**Re: Design Submission for Newbrook Carehome, Taylors Lane, Dublin (the "Development")
(the "Design Submission") / Connection Reference No: CDS21003731**

Appendix A

- [J3406-C-01D – Proposed Drainage Layout]

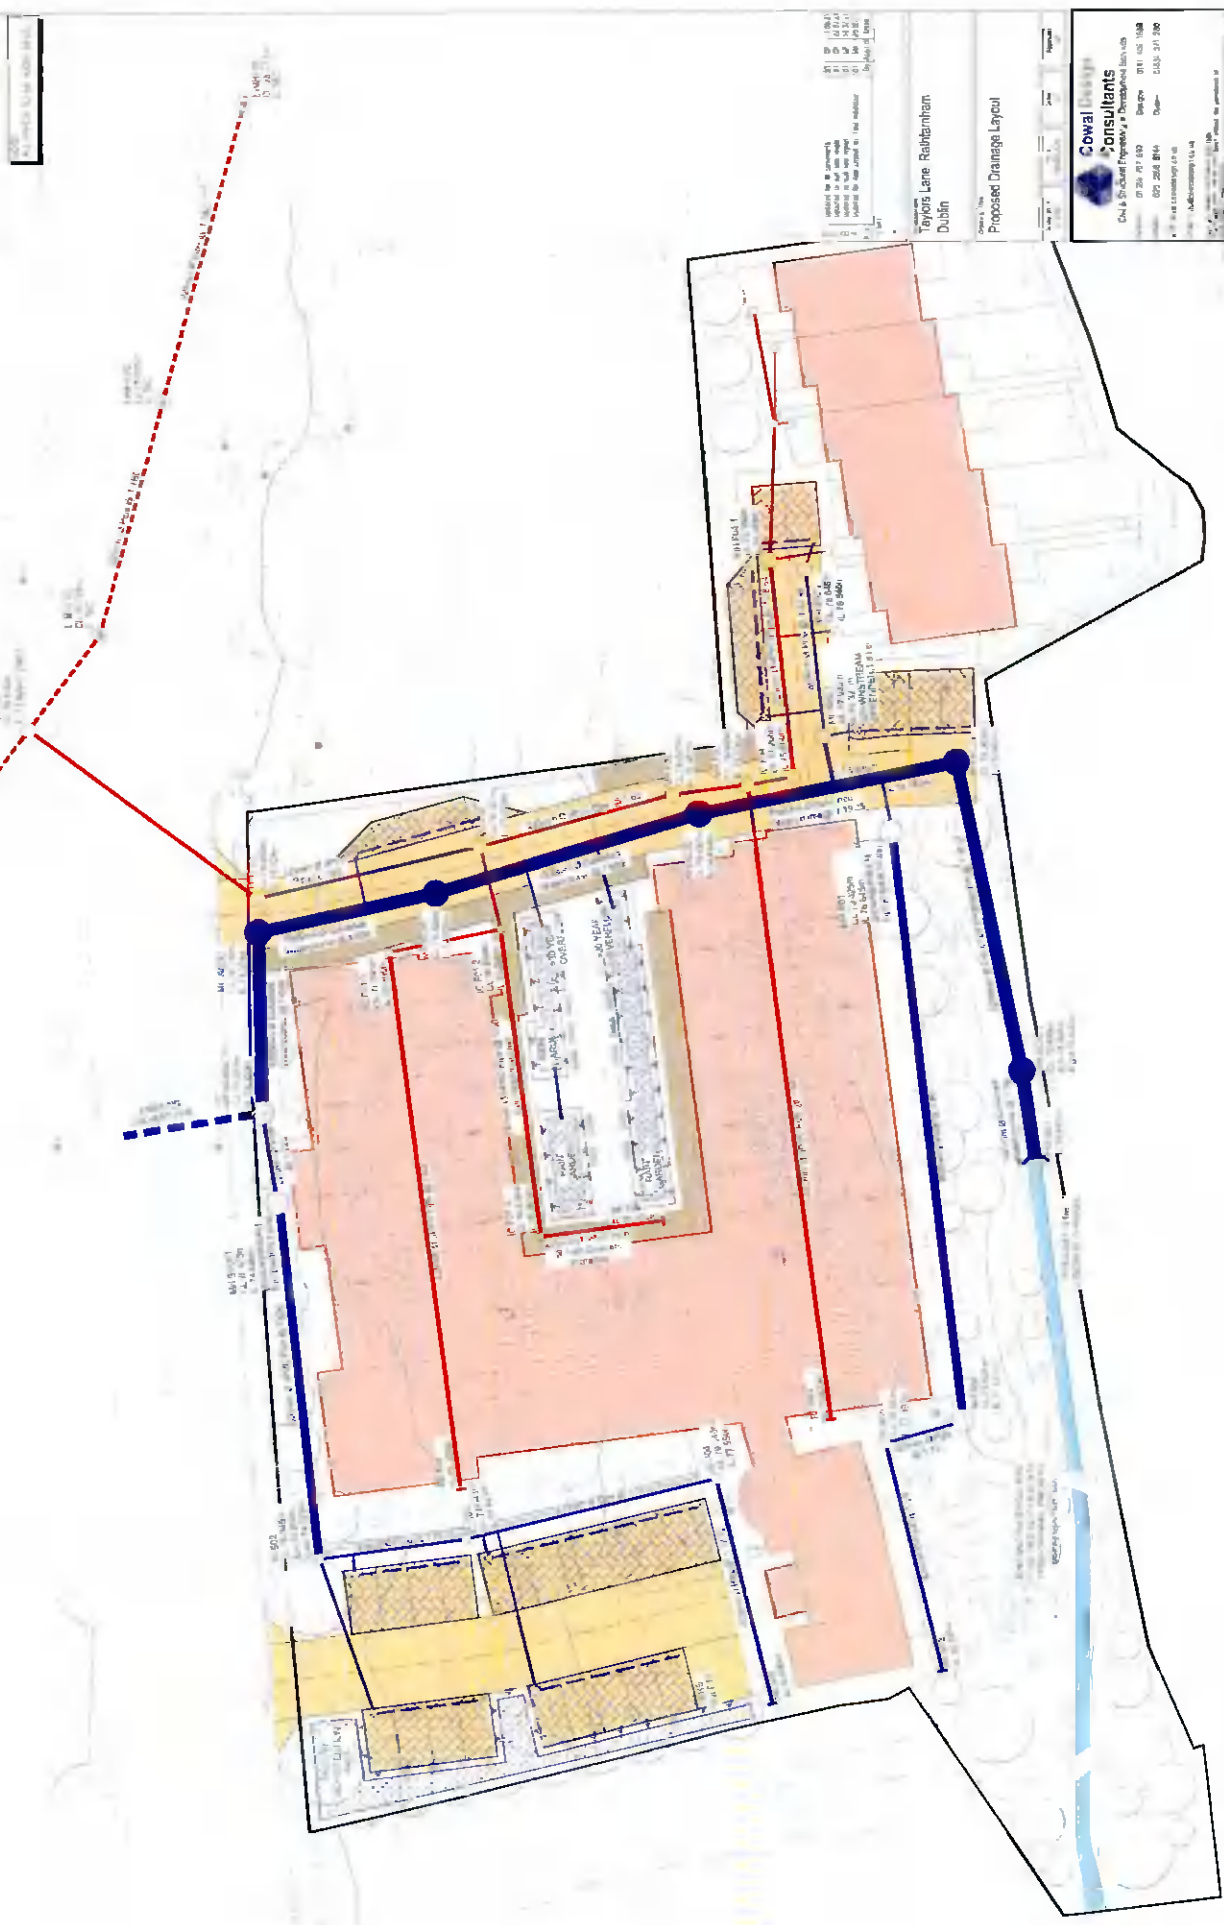
We have reviewed your proposal for the connection(s) at the Development. Based on the information provided, which included the documents outlined in Appendix A to this letter, Irish Water has no objection to your proposals.
